P 515996-C

A REPAIR

## ON-SITE SEWAGE DISPOSAL SYSTEM HOWARD COUNTY HEALTH DEPARTMENT BUREAU OF ENVIRONMENTAL HEALTH

ADDRESS: 12620 Route 108 PROPERTY OWNER: Kirit Parmar

P 515996-C

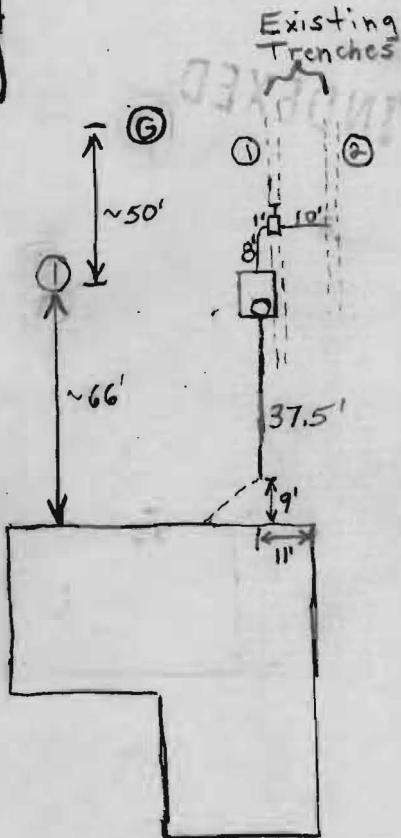
TRENCHES:	Trench to be _____ feet wide. Inlet _____ feet below original grade. Bottom maximum depth _____ feet below original grade. Effective area begins at _____ feet below original grade. _____ feet of stone below distribution pipe.
LOCATION:	
PURPOSE:	Proposed addition requires relocation of existing septic tank and partial abandonment of existing trenches. <u>One percolation test hole is to be dug closer to house to further verify that there is remaining repair area before any work is started.</u>

INSPECTION COMMENTS: 10/9/01 Approximately 30' abandoned on trench ①. Approximately 15' abandoned on trench ②. So around 150' of trench should be remaining. Which leaves enough for a 3 bedroom house considering that there is reported to be 3'-4' of stone in existing trenches. There is sufficient space remaining for 1 repair in area of pipe test holes ① and ②. (BB)
